ASC Competition Commercial, Region 7		REQUEST FOR INFORMATION  FOR  <b>Solano County Classroom and Vocational Training Center</b>		R.F.I.. NO: 11.4.1
  <b>HENSEL PHELPS</b> Plan. Bui.d. Manage.				ISSUING ENTITY: Hensel Phelps
		SHEETS: A202.1	DETAILS / SECTIONS: SK-01, SK-02	SPECIFICATIONS REF:
TITLE OR SECTION OF WORK:  Door Swing Revisions Due to ADA Clear Swing Requirements				
PERTENENT PROBLEM SECTION: Section 11: Quality Control			ISSUED BY:  DATE:	
WRITTEN DESCRIPTION OF PROBLEM - ATTACH SKETCHES AS REQUIRED:  Reference A202, A202.1 and Mezzanine Shop Drawing Submittal Submittal 0009-13 49 19-2  The current stair design at 'Mezzanine B' creates conflicts with the doors at the Classrooms and Tool Rooms located below. In order to maintain proper clearance requirements for ADA accessibility, the following items need to be addressed:  1. The mezzanine landing at the tops of the stairs at level 2 require structural columns at each corner of the landing. The current configuration of the double doors to the Classroom B138 would cause the southern leaf of each door to hit the required stair column (SK-01). Please confirm it is acceptable to revise the double doors to be one 4'-0" d

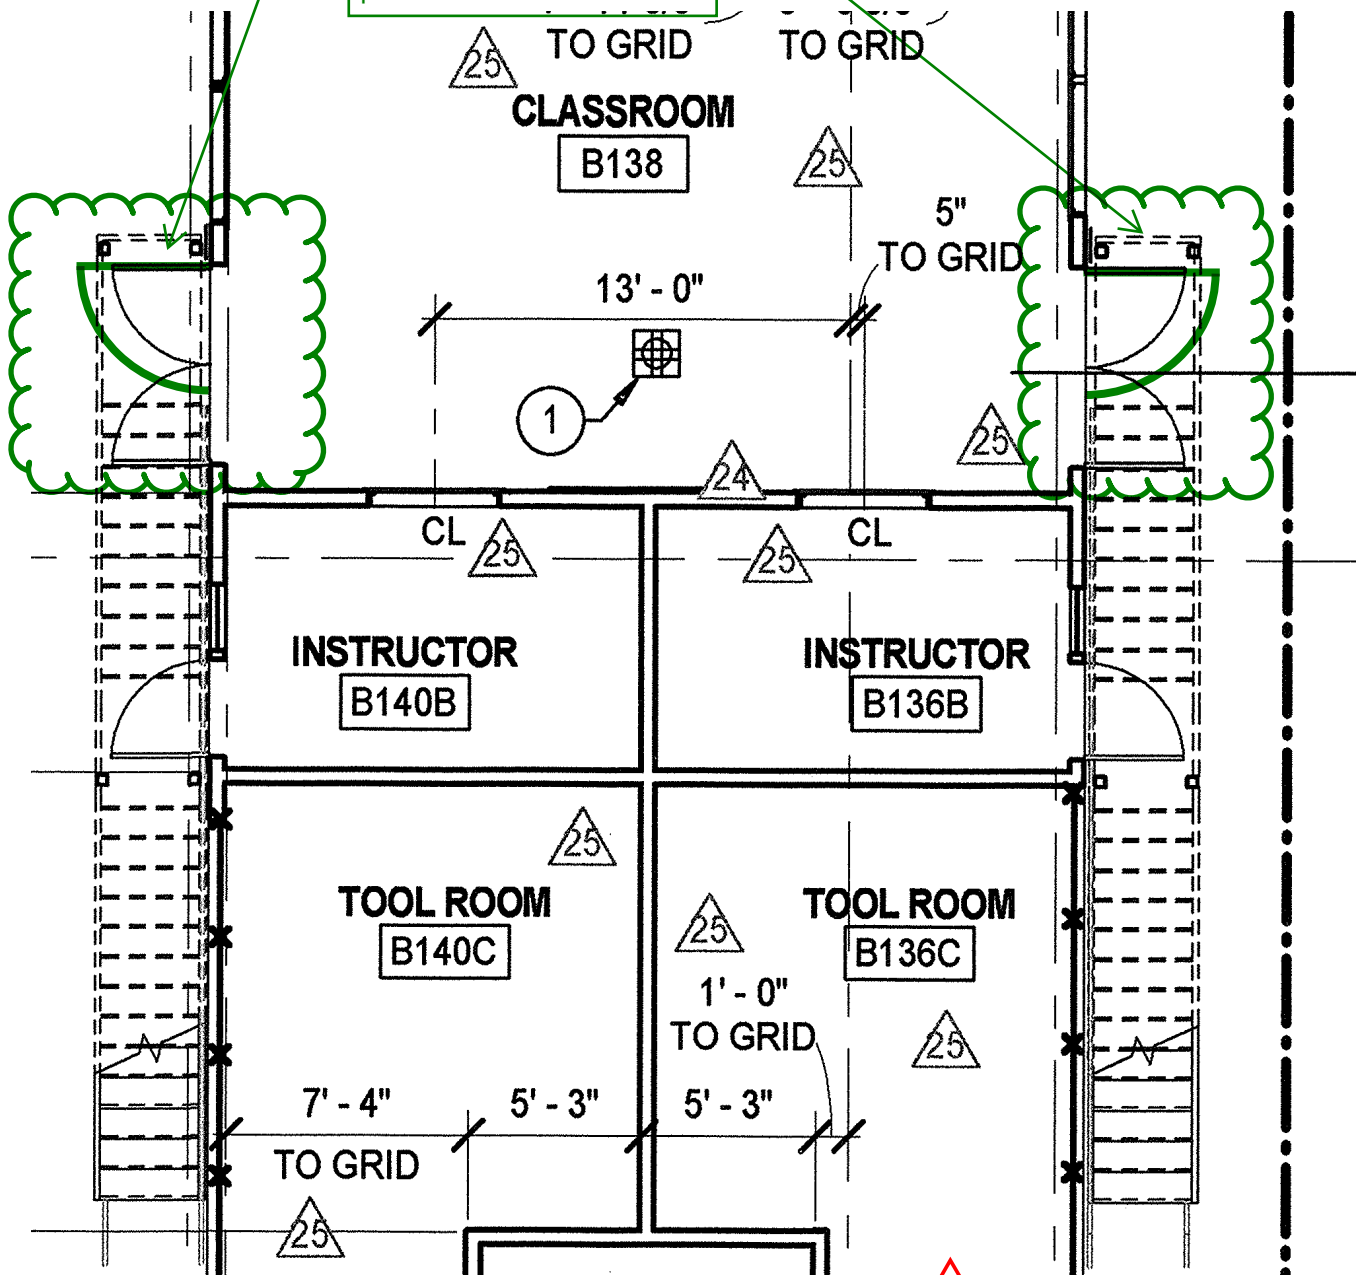
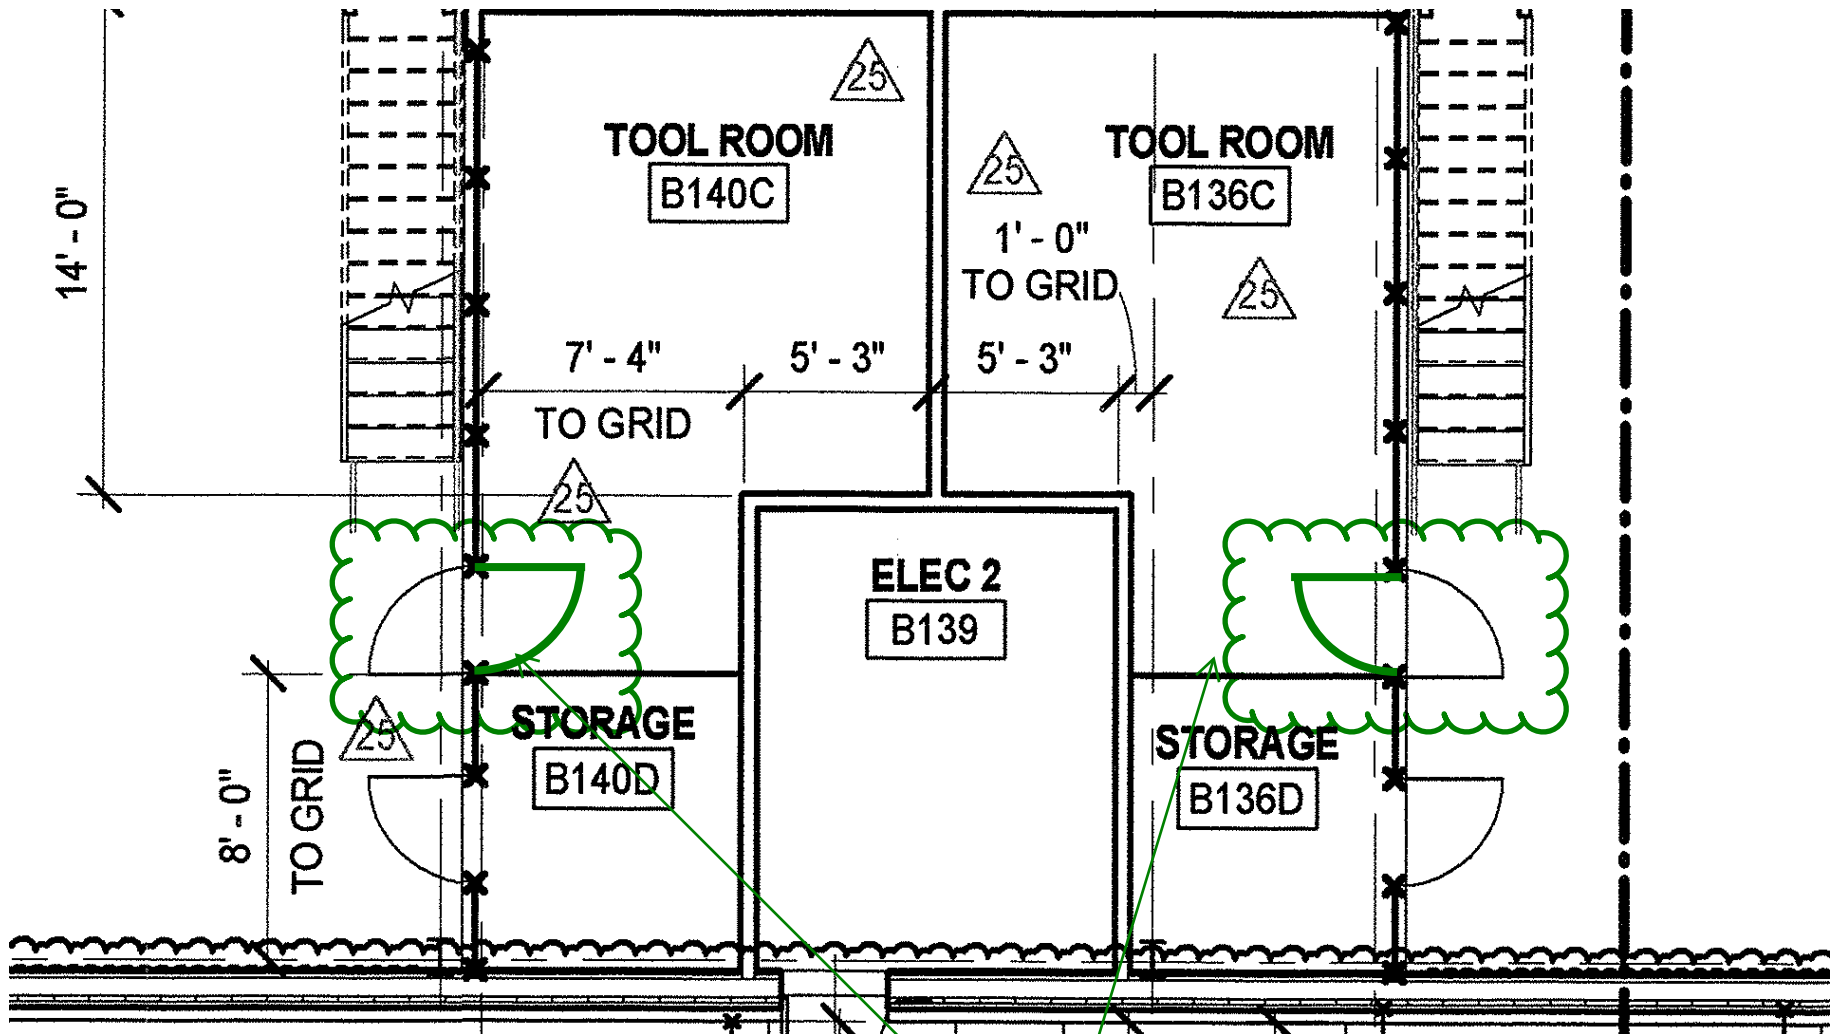
Current layout does not provide minimum 18" clearance at pull side required by ADA due to conflict with stair guardrail. Please confirm it is acceptable to revise the door swing as shown.

Please confirm it is acceptable to revise to single 4'-0" door and increase stair landing size. Please provide updated landing size to allow for 18" minimum space at pull side.
